OFFICIAL STAR CLASS MEASUREMENT CERTIFICATE

Report from International Measurement Committee

Star No. 2652

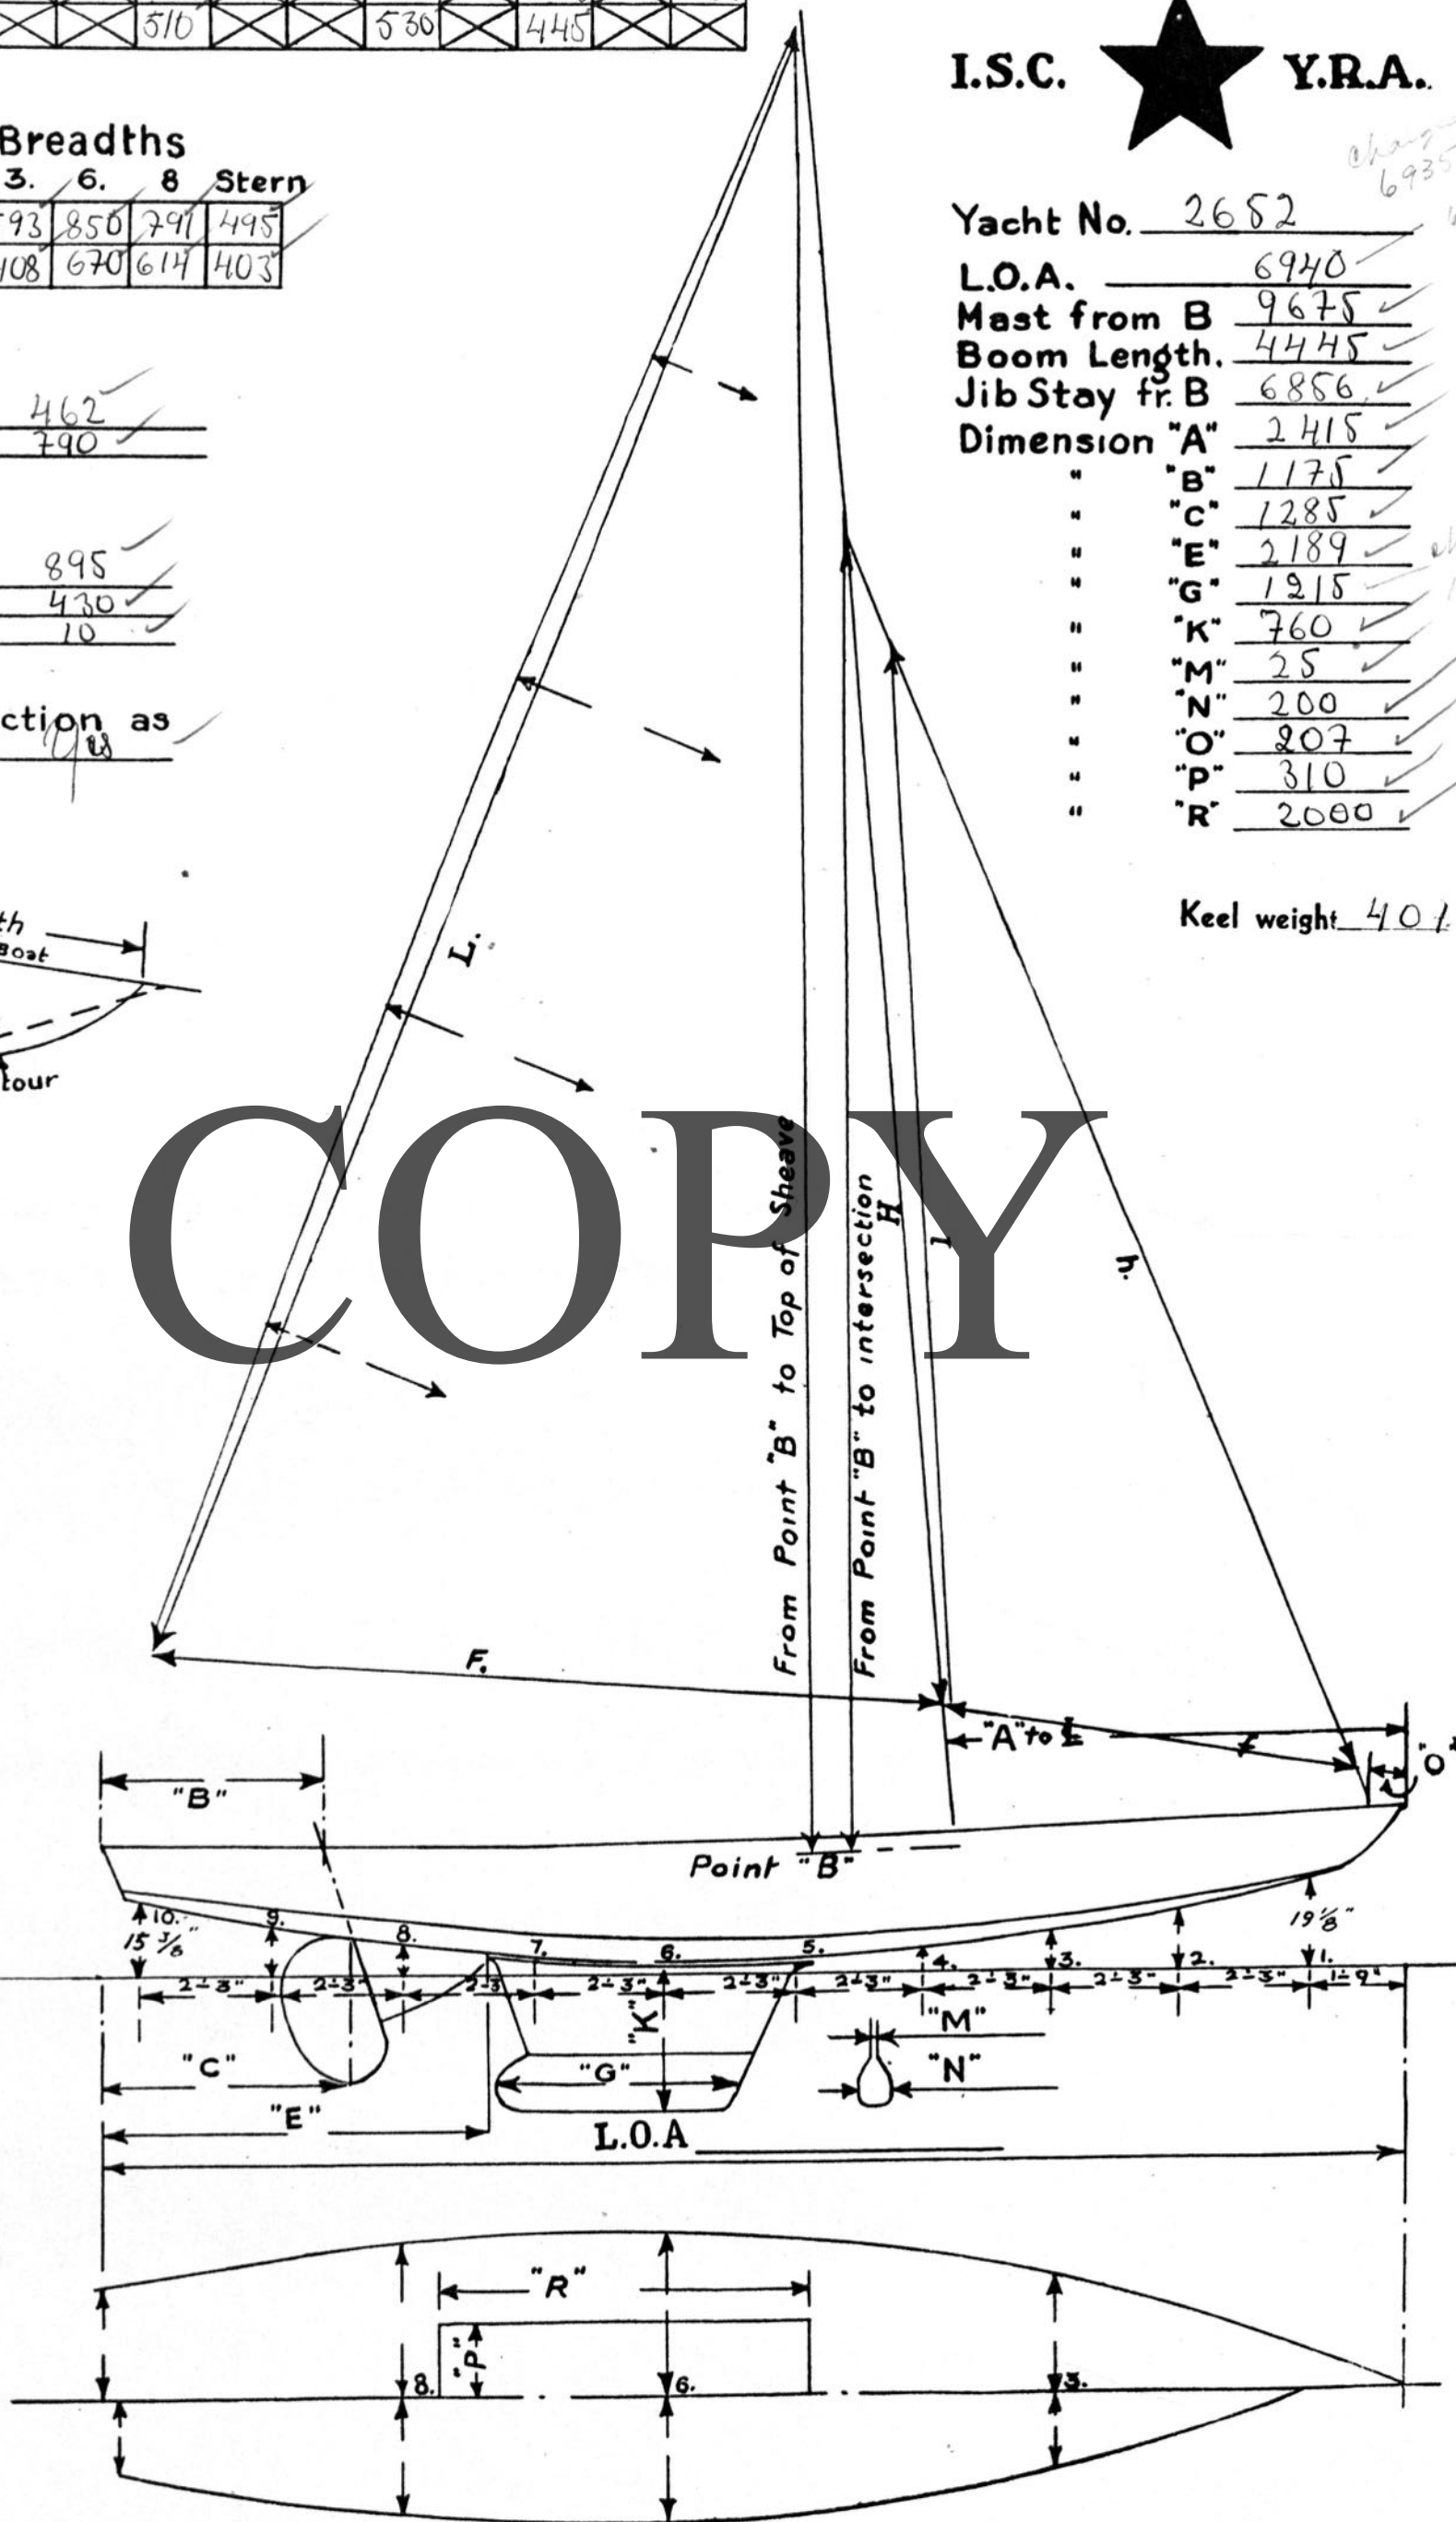
Chine height at Station 8 measures 233 - minimum at this point is 245

Length over all measures 6940 - maximum is 6935

Dimension G is shown as 1215 - minimum is 1235

N:r 2652: I made a mistake with the measurement of Chine height at Station 8. At remeasurement the measure was 252 m/m. Sength over all are corrected from 6940 to 6935 m/m.

Dimension G is changed (welding) from 1215 m/m to 1245 m/m.

The weight of the keel add to 0.3 kg.
